UNITED STATES PATENT AND TRADEMARK OFFICE

APPLICATION NO.	FILING DATE	FIRST NAMED INVENTOR	ATTORNEY DOCKET NO.	CONFIRMATION NO.
10/599,303	09/25/2006	Jonas Graphenius	495.1106USN	1779

Office Action Summary	Application No. 10/599,303	Applicant(s) GRAPHENIUS, JONAS	
	Examiner MICHAEL D. DAVID	Art Unit 3641

DETAILED ACTION

-Modified figure reproduced from Morgan (US Patent 4090005)-

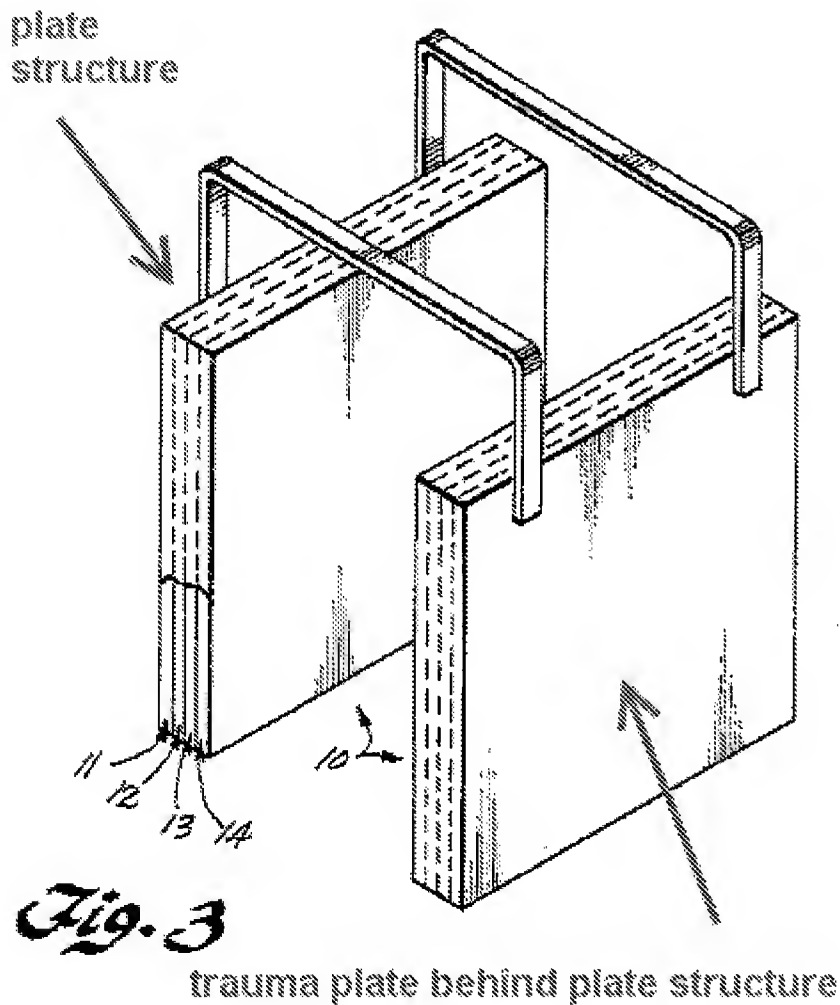
Regarding claim 7, Morgan discloses the method of claim 1 wherein the method further comprises placing a trauma plate behind the plate structure (see fig. 3 below).

Regarding claim 10, Morgan discloses wherein the method further comprises providing a second textile layer and a second semi-solid layer (fig. 3 shows two of the same panels/stacks, one being in front of the person and one being in the back. since there two stacks/panels are identical, the second stack/panel has a second textile layer and second semi-solid layer). See claim 1 rejection above.
